Staff Report

To: Salt Lake City Planning Commission
From: Eric Daems, Senior Planner, eric.daems@slcgov.com or 801-535-7236
Date: March 10, 2021
Re: PLNPCM2020-00661 Design Review

Design Review

PROPERTY ADDRESSES: 119 W 1400 S, 1411 S. Jefferson Street, and 1425 S. Jefferson Street
PARCEL ID's: 15-13-229-006-0000, 15-13-229-007-0000, 15-13-229-002-0000
MASTER PLAN: Central Community
ZONING DISTRICT: CG (General Commercial)

LEVEL 1 FLOOR PLAN

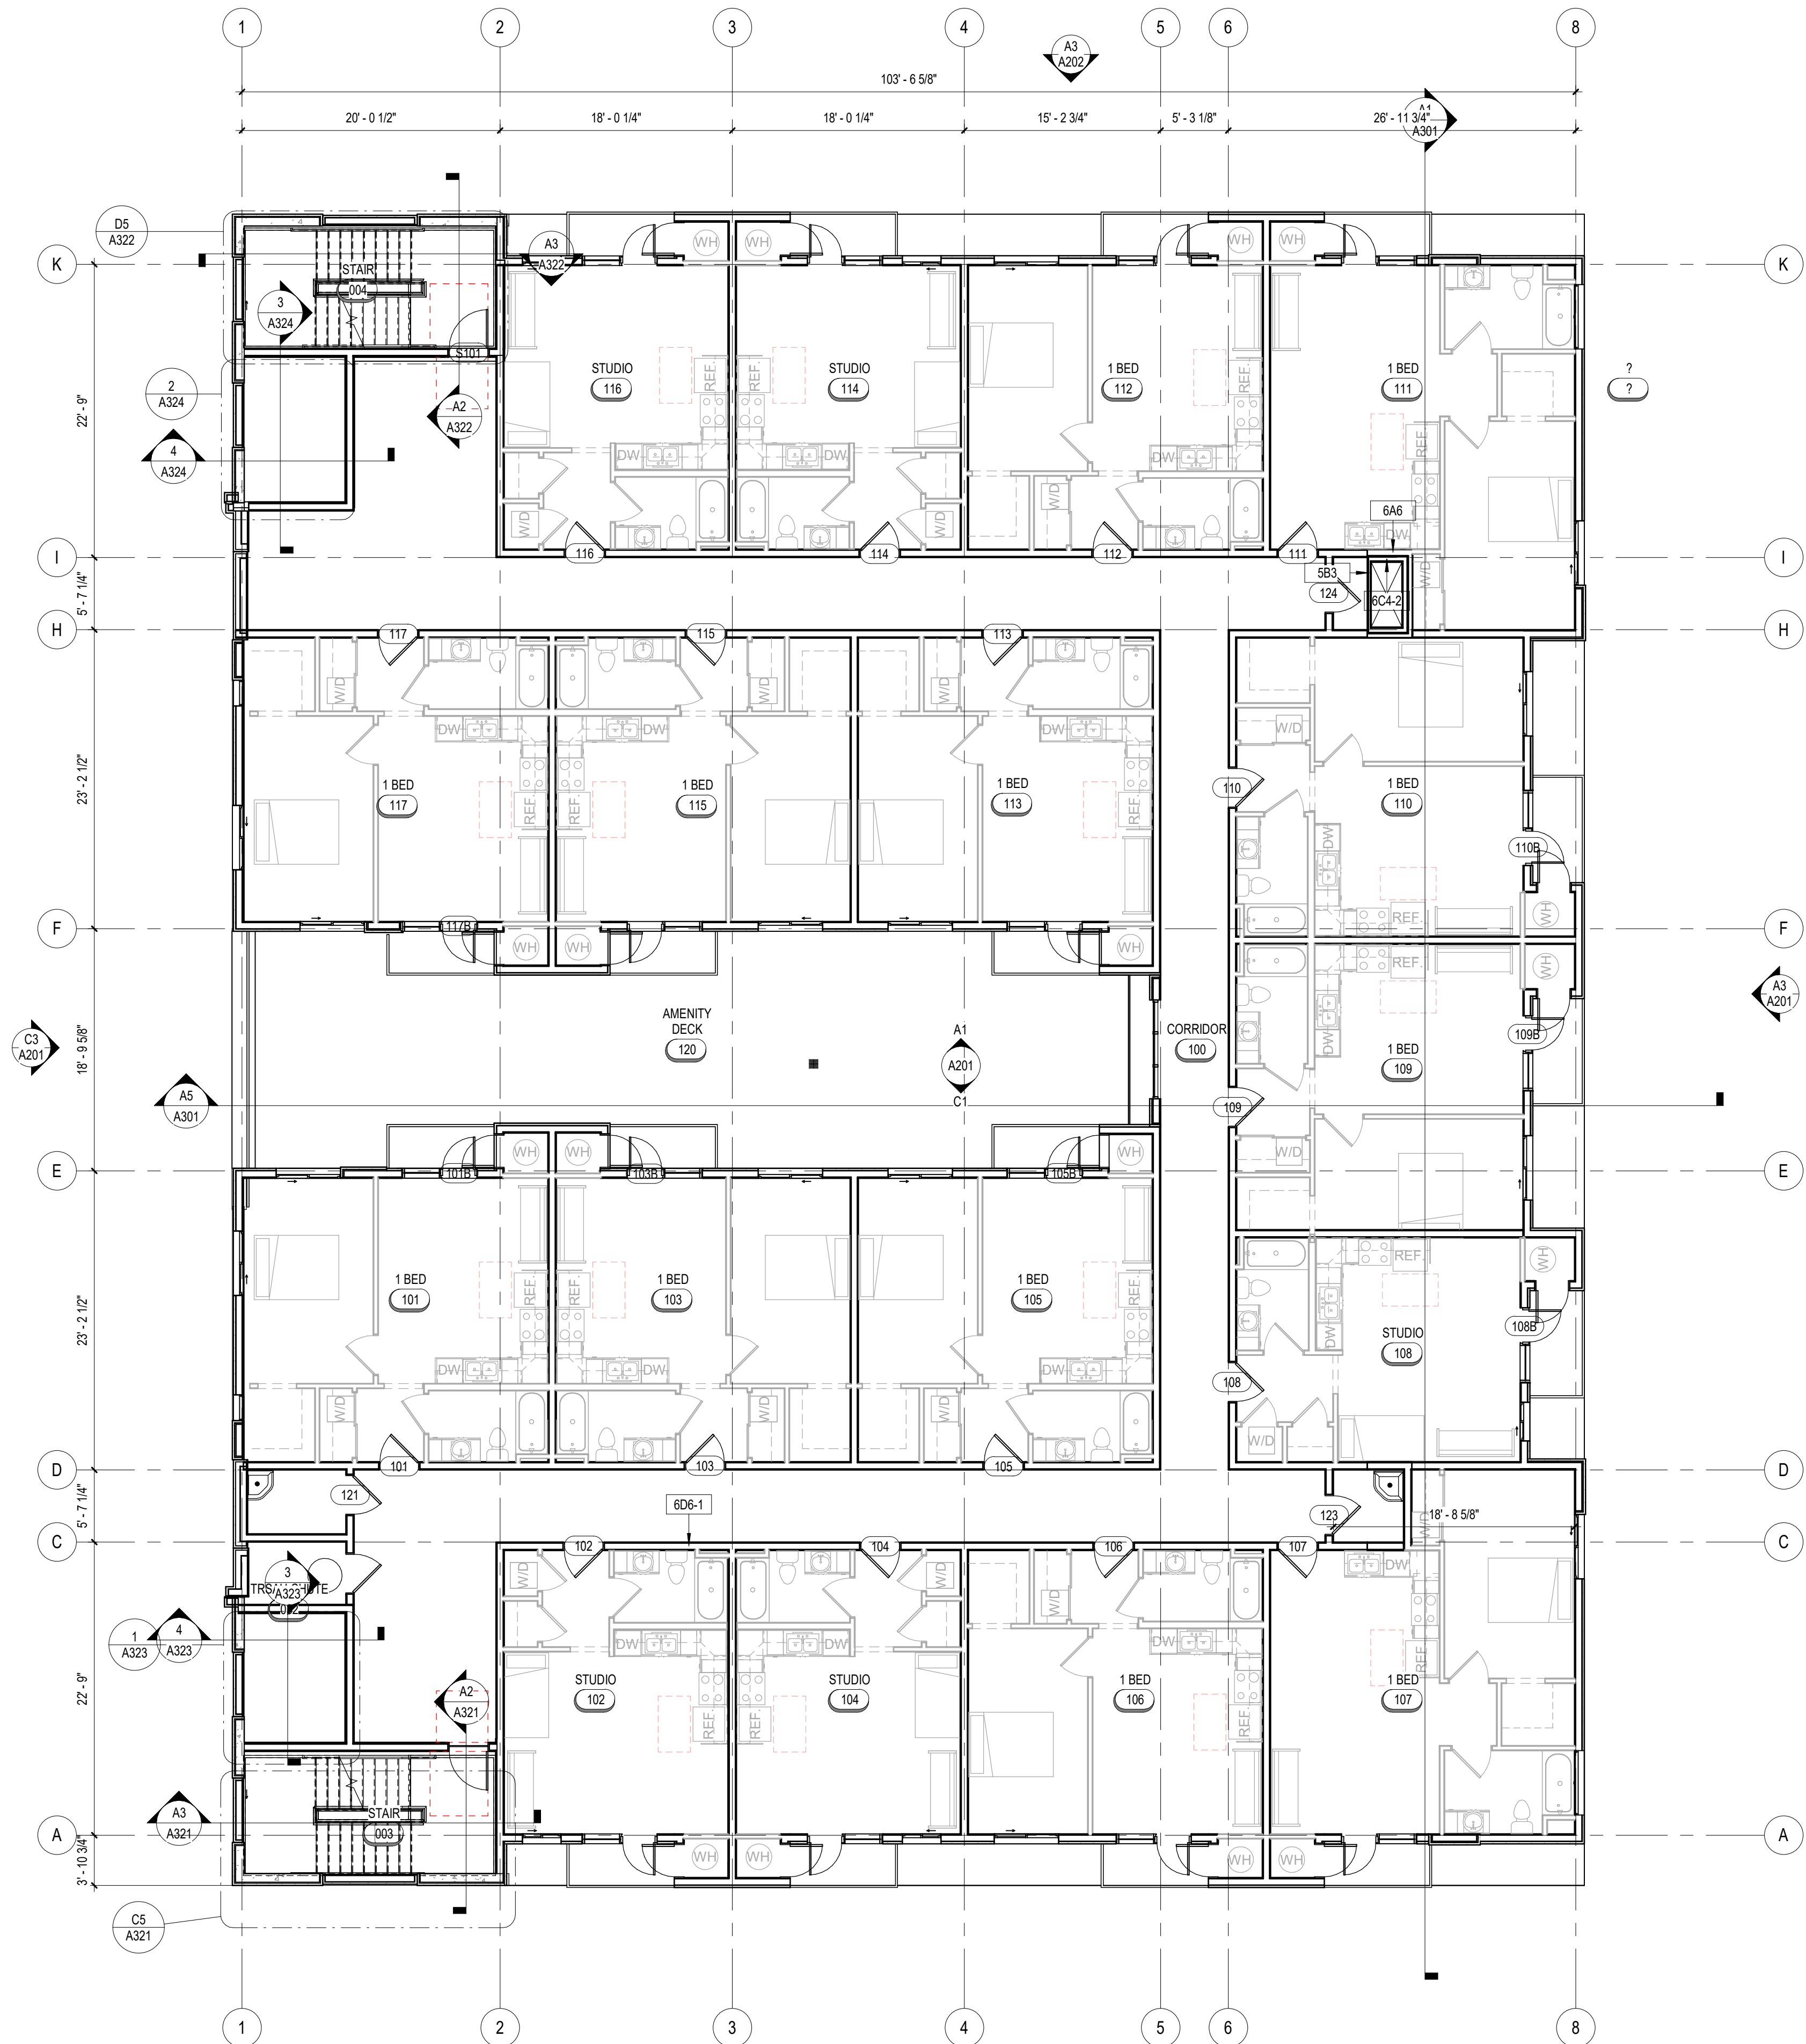
1. Alter building entrance along 1400 South to lead into occupiable space and to include more pedestrian-oriented design elements.
2. Revise the ground floor façade along 1400 South to include a solid-to-void ratio of windows and doors more in character with the neighborhood.

Along Jefferson, the proposal largely meets those requirements. However, more could be done with the entry along 1400 South to meet the intent of the code.

The term “operable” is not defined in our code. Webster’s dictionary defines it as “fit, possible, or desirable to use”. Although the door facing 1400 South is possible to use, more could be done to make it desirable to use. Staff is recommending that the door lead into occupiable space. That could include a lobby or other common area. The

entry could also be better defined with materials, awnings, windows, or other design elements.
